# UNITED STATES PATENT AND TRADEMARK OFFICE

10/828,939

## Office Action Summary

## **DETAILED ACTION**

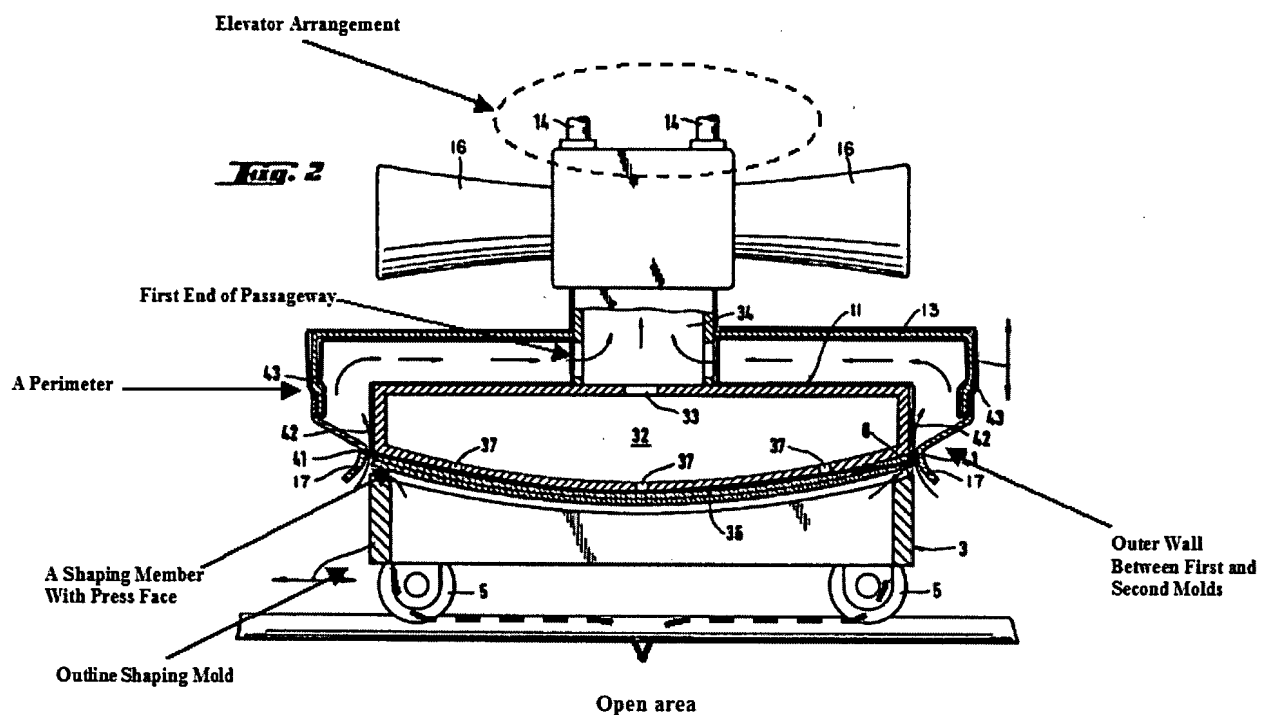
Claim 1, 2, 4-7, 12-18, 24- 29, 38, and 40 are rejected under 35 U.S.C. 102(b) as being anticipated by Kuster (US 5,713,976). Briefly, Kuster teaches a sheet bending apparatus comprising a concave annular bending block serving as both a bending ring and means for conveyance and a convex bending block acting from above on the surface of the glass sheet. With particular respect to claim 1, Applicant is directed to the annotated excerpt figure 2 below from the instant reference.

The Kuster apparatus presents a "major surface" of a first mold here indicated by a bold black line. This major surface defines the claimed features including the "perimeter" and the "shaping member" within and offset from said perimeter. The apparatus further provides "at least one passageway in the major surface" in a "non-shaping area" [**Claim 38**] which lies between the shaping member and the perimeter.

As clearly set forth in the prior office action, the Kuster reference teaches that the first mold is paired with a second mold or "outline shaping mold". The latter mold consists of spaced end rails and spaced central rails which collectively define a continuous, annular sheet supporting surface [**Claim 2**] and an "open area". An "outer wall" (17) is provided between the sheet supporting surface and the first end of the passageway, thereby forming a "boundary" with or between the sheet supporting surface and said passageway. An "elevator arrangement" (14) is provided to for relative movement of the first and second molds.

The outer wall described above is mounted to the major surface of the first mold [**Claim 4**], and in cooperation with the first and second molds, said outer wall defines an enclosure during a pressing operation (Column 4, lines 36-38). This outer wall surrounds and is spaced from the first end of the passageway and the shaping member

[**Claim 5**] of the first mold and has one part of *an aligning arrangement (17)* [**Claim 7**] which cooperates with an aligning arrangement of the second mold (eg. the rails) as claimed.

Kuster teaches (column 4, Lines 23-38) that the “surrounding flange (17) which reduces the gap between the casing (13) and the monolithic convex bending block (11)” can be made to “eliminate the gap completely and by appropriate means to close the space between the annular bending ring (3) and the casing (13)”. Where surrounding flange (17) or the outer wall eliminates “the gap completely”, it is understood that the outer wall is effectively “mounted to” the exterior peripheral surface of the outline shaping mold or “to the central rails and the end rails” as claimed [**Claim 6**]. In light of this disclosure, Examiner asserts that the Kuster apparatus defines at least one configuration wherein the first and second shaping molds serve as opposite sides of an enclosure and wherein the sheet supporting surface of the second mold, the first end of the passageway, and the shaping member of the first mold are all internal to and therefore “face” the enclosure. It is further evident from the above figure 2 excerpt that in the “enclosed configuration”, the Kuster apparatus provides fluid communication from “the open area” through “at least one passageway” (37) and (33) to a second opening positioned outside the enclosure (e.g. through the suction fans (16)) to allow fluid communication between the interior and exterior of the enclosure.

Regarding **Claim 12** and in light of the rejection of Claim 6 above, the rails in figure 2 above are understood to have an “I” shaped cross section with the upper end providing the sheet supporting surface. Further as outlined in the rejection of Claim 6,

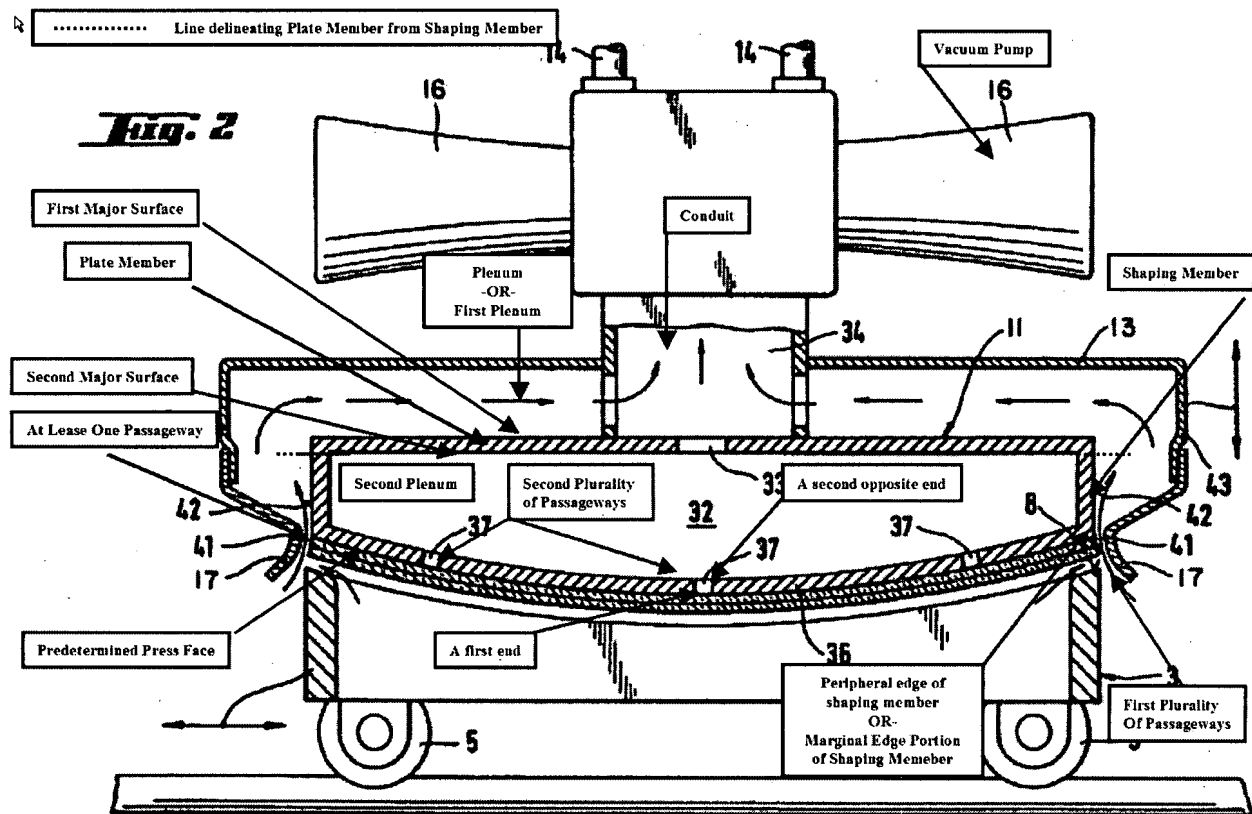
the outer wall has one end "mounted" to the outer vertical surface of the "I" rail and extends away from the "I" rail and the open area during a press operation.

Claims 13, 14, 15, 16, 17, and 18 are anticipated in light of the second annotation of Figure 2 from the Kuster reference presented immediately above. Individual elements indicated on the first annotated version of Figure 2 have been re-annotated where appropriate to reflect applicant's chosen lexicon in the identified claims.

**Claim 29** is anticipated in light of the combination of the annotated Figure 1 and the Figure 2 second annotation as presented above. Since the Fans (16) in figure 2 are in direct fluid communication with the open area of the second shaping mold through passageways (33) and (37), the Kuster apparatus is understood to be capable of moving air "through the open area of the second mold"

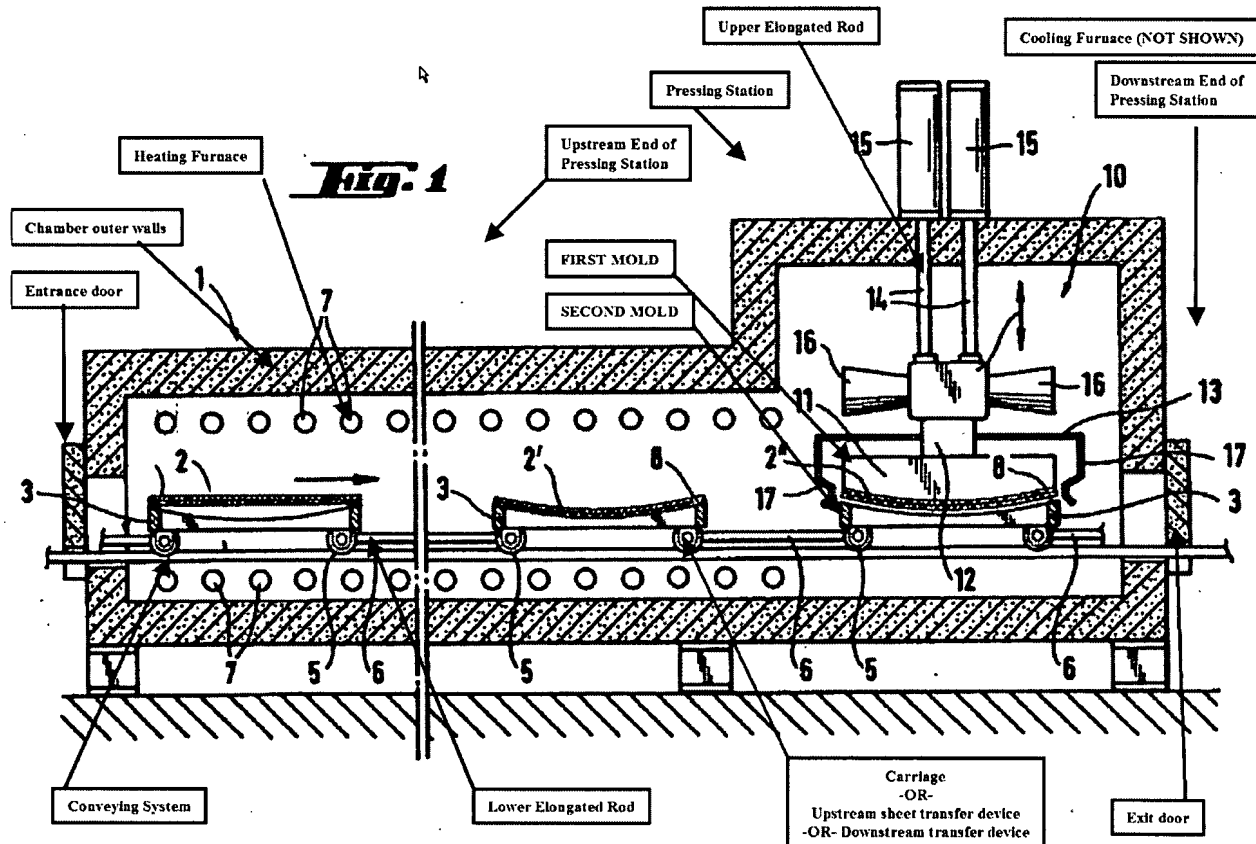
Claims 24, 25, 26, 27, and 28 are anticipated in light of the annotated excerpt figure 1 presented below. Said figure has been edited with examiners annotations in order to assist correlation of prior art teachings with applicants claimed elements in

applicants chosen lexicon. Details of the operation are also set forth in the immediate reference Column 3, line 56 through Column 4, line 49.

**FIG. 5**

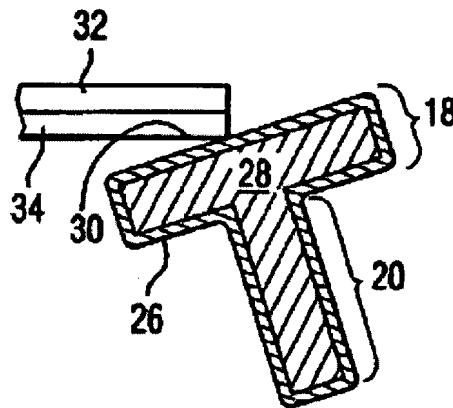
With respect to **Claim 8**, Kuster teaches that the central and end rails have a "I" shaped cross section (as evidenced in the Fig 2 excerpt above) while failing explicitly set forth that they may be constructed with a "T" shaped cross section as claimed. Skeen teaches (Column 2, Lines 3-6) that glass bending ring mold "rails themselves are usually pre-shaped to have a shape to support the unbent sheet while also supplying the mold for the curved or bent sheets" and that (see Fig 5 excerpt and Column 2, Lines 36-39) "the rail member itself may be a bar member that supports the glass sheets slightly inboard of the glass sheets periphery or it may be an "L" or "T" shaped member." It would have been obvious to one of ordinary skill in the art at the time of the invention to modify the central and end rails of the Kuster process to utilize a "T" shaped member as taught by Skeen. This would have been an obvious modification to one seeking to provide adequate support to both an unbent and bent glass sheet.

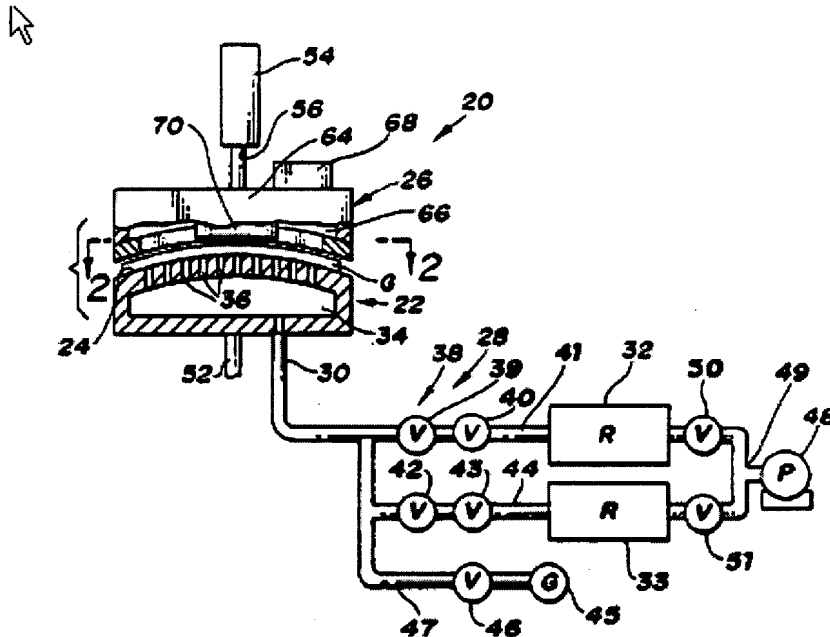
Regarding **Claim 9** and in light of the rejections of Claims 6 and 12 under 35 U.S.C. 102(b), Kuster teaches that the surrounding flange (17) portion of the outer wall can "eliminate the gap completely" by closing "the space between the annular bending ring (3) and the casing (13)" and as such is "connected" to the outer surface of the rail and extends away from said rail. In accord with the obviousness type modification set forth in the rejection of Claim 8 above and the premise set forth in Claims 6 and 12, it would be obvious to "connect" the surrounding flange (17) portion of the outer wall to the outer surface of the horizontal member of the "T" rail in order to "eliminate the gap completely" between the ring and the casing as taught by Kuster.

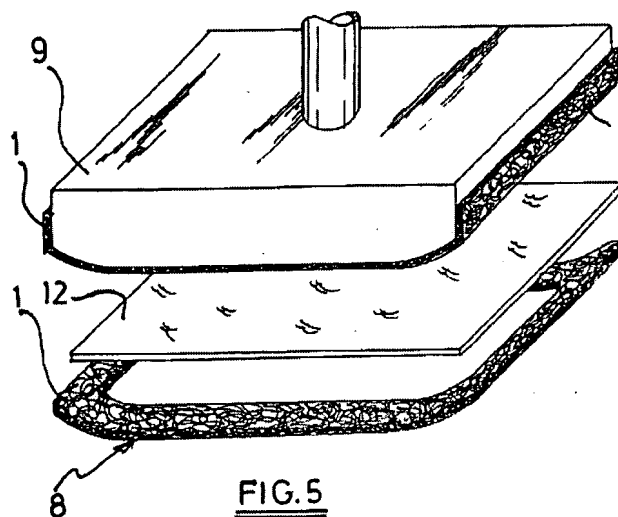
the second plenum should be connected via a valve having a first open position and a second open position. Shetterly, teaches a vacuum press mold utilizing a valve system (indicated as V in excerpt image below) to control application of vacuum or pressurized gas to the perforated pressing mold.

Further, Two-way valves of the type described by the applicant are old and well known tools in the art for switching a system between vacuum and pressure. It would have been obvious to one of ordinary skill in the art at the time of the invention to utilize a two-way valve or valve system as taught by Shetterly to control the application of "an excess pressure" in the second plenum as taught by Kuster. The use of a valve would have been obvious for one seeking selective application of either elevated pressure or vacuum to a system.

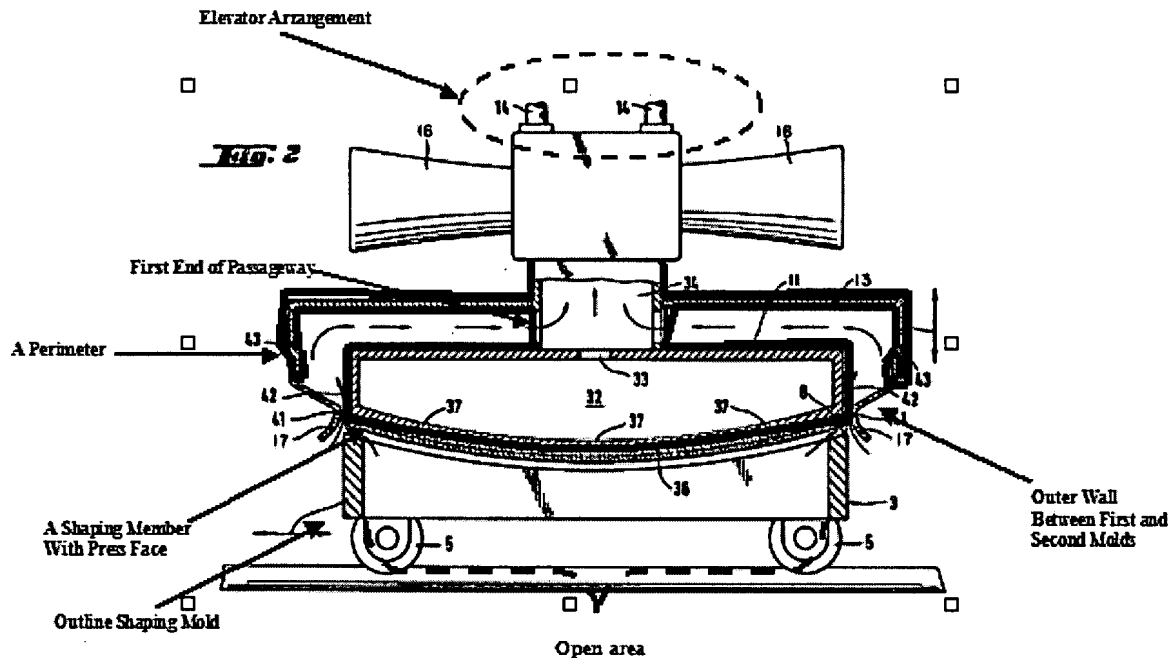
As currently presented, the instant claim does infact read an outer wall defining a boundary which is within the boundary defined by the outer wall". For at least this reason, the rejection under 35 U.S.C. 112, second paragraph as presented in the office action dated March 7, 2007 is proper. Applicant is strongly advised amend lines 14-16 to recite the following in order to clarify the metes and bounds of the of the instant claim

and to unambiguously recite the intended invention; “an outer wall between the first and second molds, the outer wall defining a boundary ~~with~~, wherein the sheet supporting surface and the first end of the passageway are located within the boundary defined by the outer wall.”
